Subject: UniStar Nuclear Energy, NRC Docket No. 52-016
Supplemental Response to Request for Additional Information for the
Calvert Cliffs Nuclear Power Plant, Unit 3,
RAI 332, Ultimate Heat Sink

**Supplemental Response to
NRC Request for Additional Information,
RAI 332, Question 09.02.05-22,
Ultimate Heat Sink,
Calvert Cliffs Nuclear Power Plant, Unit 3**

NRC Feedback Comments on Initial Response

Figure 9.2-3— {Normal Makeup, Emergency Makeup, Blowdown & Chemical Treatment}

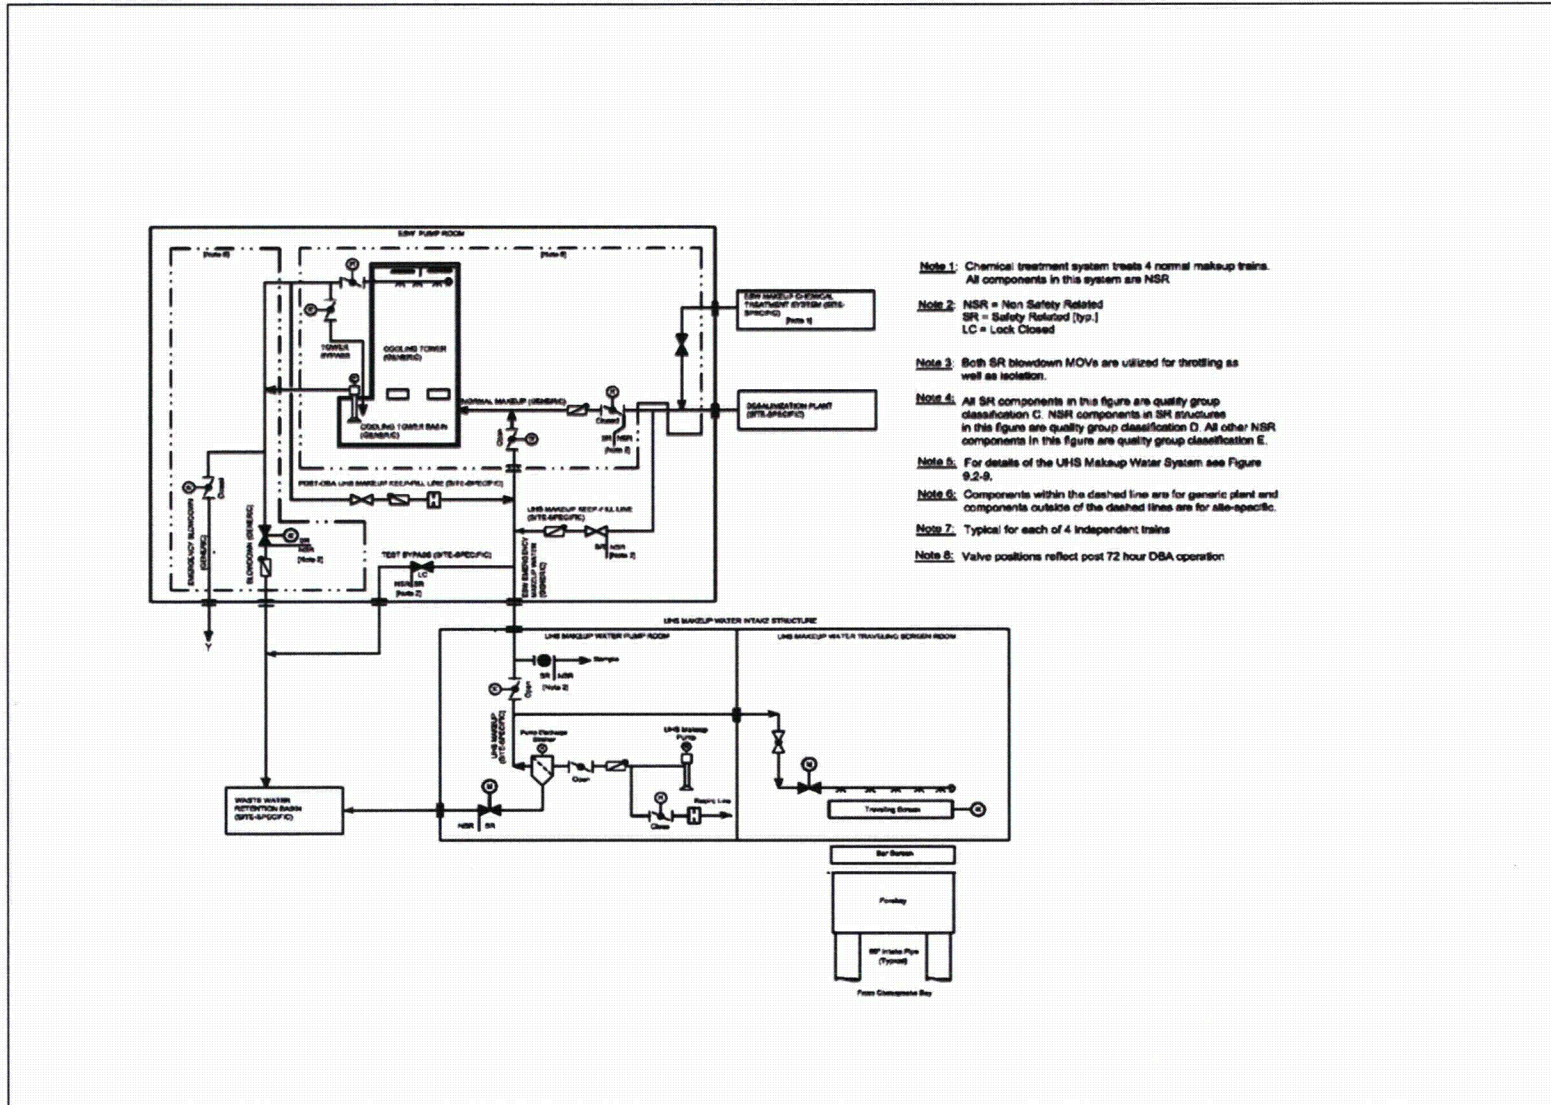
Page 31/51 – dashes for buildings - missing some labels.

Page 31/51 – SR/NSR boundary moved from AA019.

Page 31/51- UHS makeup keep fill (gate and check) – in which building are these valves located?

Page 31/51 – consider adding pressure gauge to verify keep NSR fill is operating correctly.

Response: FSAR Figure 9.2-3 has been updated to incorporate missing dashed borderlines and labels for the ESW building borderlines. Solid lines are added to the figure to represent buildings and dashed lines are to show the separation of site-specific components and generic plant components.

Response: FSAR Figure 9.2-3 has been updated to relocate the SR/NSR boundary to the upstream side of the motor-operated site-specific NSR Normal Makeup Water System isolation valve 30PED10/20/30/40 AA019.

Response: FSAR Figure 9.2-3 has been updated to show the UHS Makeup Water Keep-Fill gate valve and check valve located inside the ESW building. All ESW System and UHS Makeup Water System valves are located inside the ESW building including the Test Bypass and Post-DBA UHS Makeup Keep-Fill lines.

Response: A pressure gauge is not required to verify that the NSR UHS Makeup Keep Fill-Line is working correctly. The UHS Makeup Keep Fill-Line is operational during normal plant operation. During this time the Normal Makeup Water System lines are at the higher pressure than the standby UHS (Emergency) Makeup Water lines for the operating and non-operating trains. However, level instrumentation with alarm is provided in the UHS (Emergency) Makeup Water System near the U.S. EPR Emergency Makeup Water Isolation valve, to indicate a postulated unfilled condition of the system.

Figure 2.4-3— {ESWS Emergency Makeup Water System Functional Arrangement}

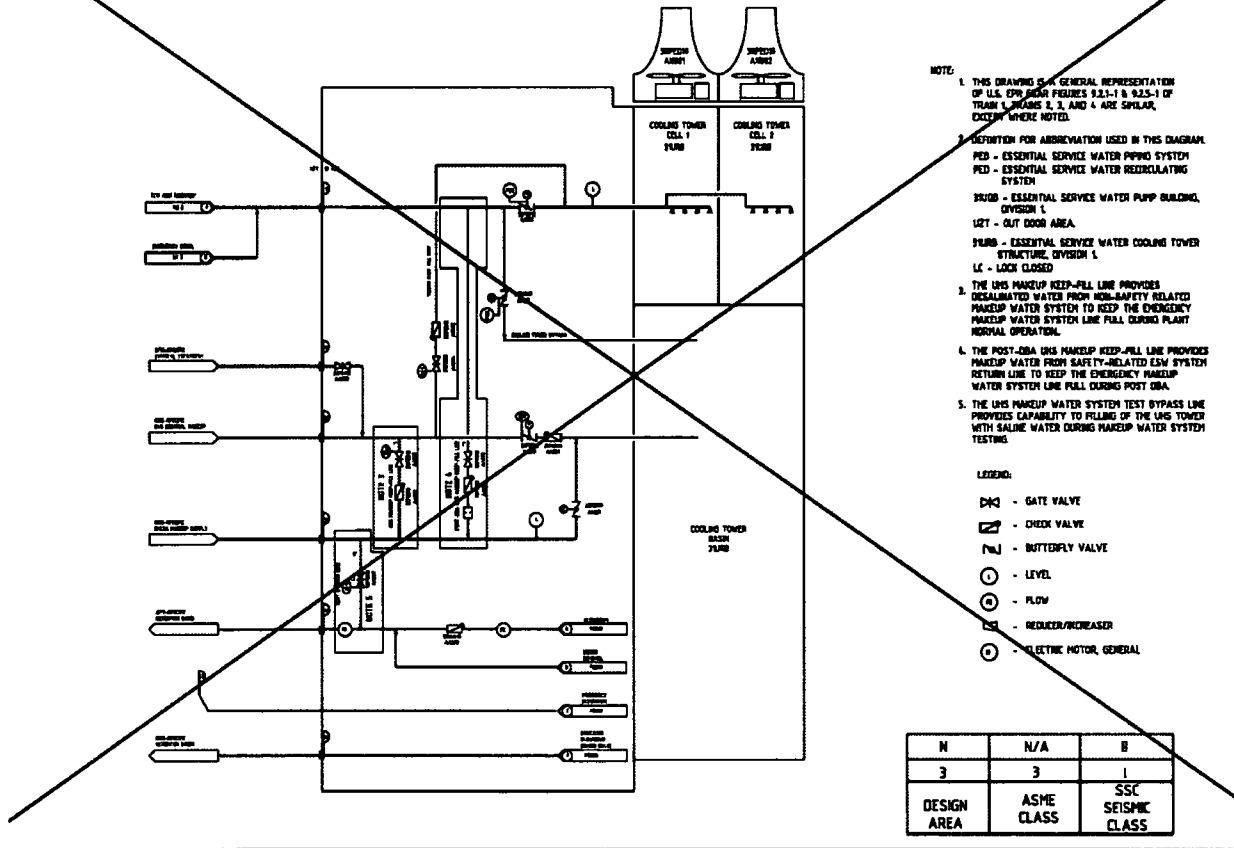
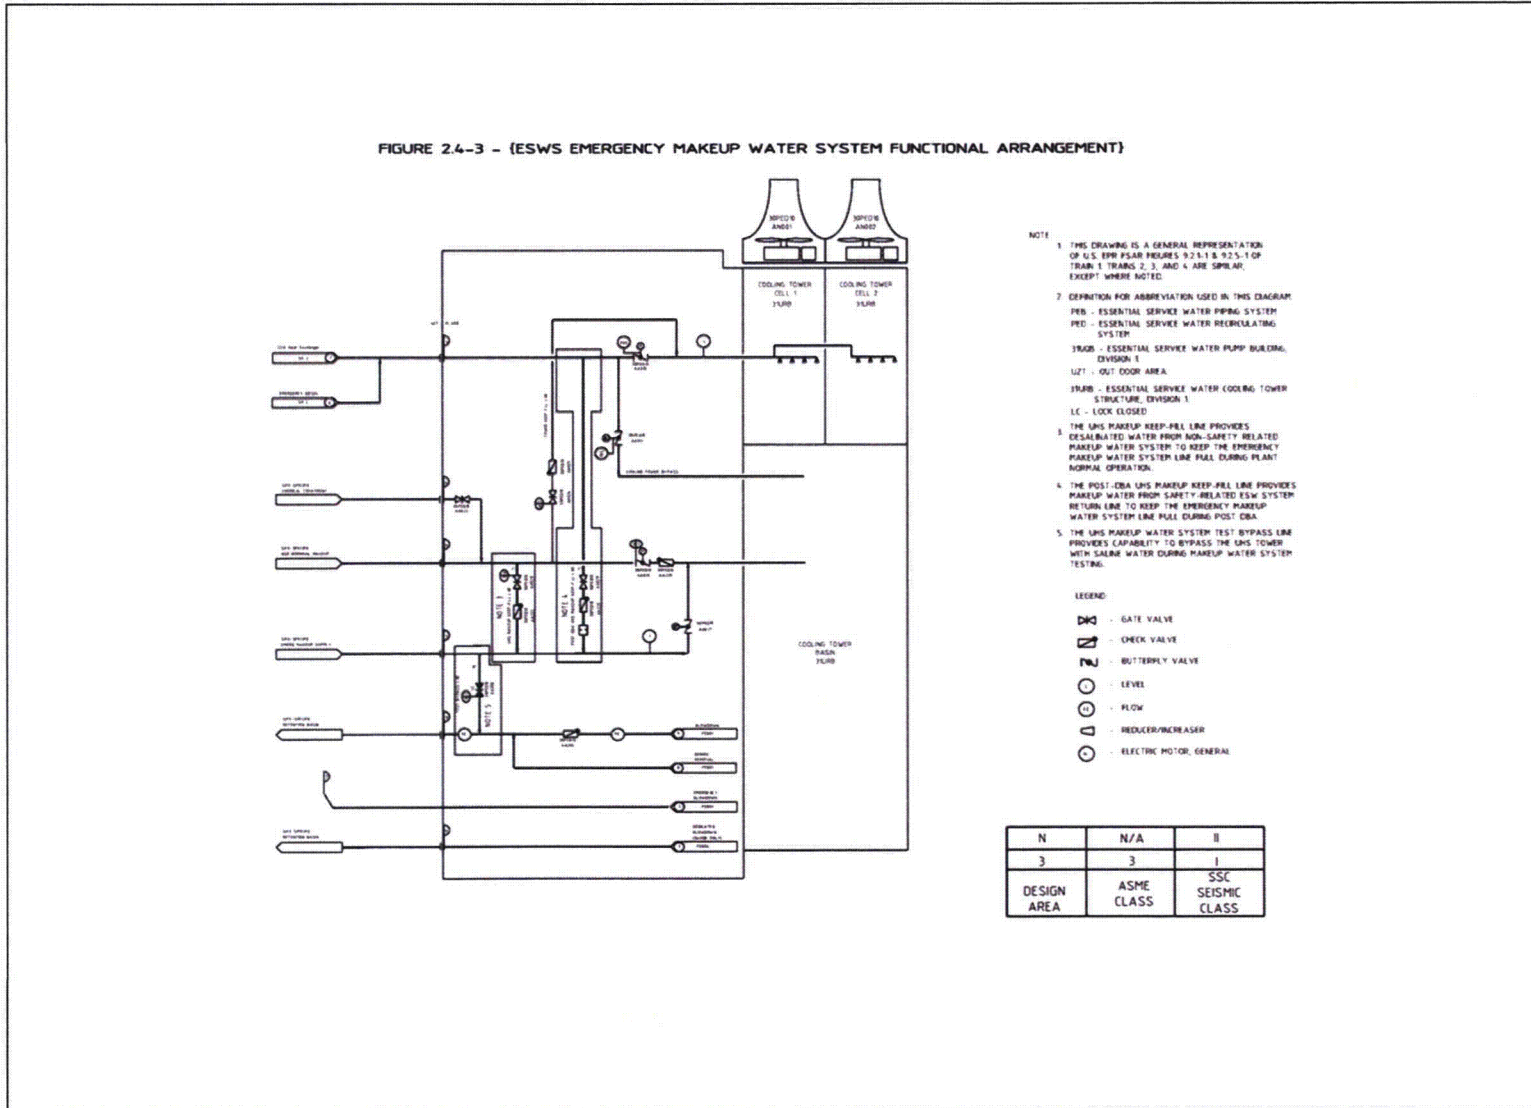
Comment: Page 51/51 – note 5, “to filling of the UHS tower with saline” vs. “to bypass of the UHS tower with saline” Consider correcting to bypass saline.

Response: COLA Part 10 ITAAC Figure 2.4-3 – ESWS Emergency Makeup Water System Functional Arrangement, Note 5 has been updated to read “THE UHS MAKEUP WATER SYSTEM TEST BYPASS LINE PROVIDES CAPABILITY TO BYPASS THE UHS TOWER WITH SALINE WATER DURING MAKEUP WATER SYSTEM TESTING.”
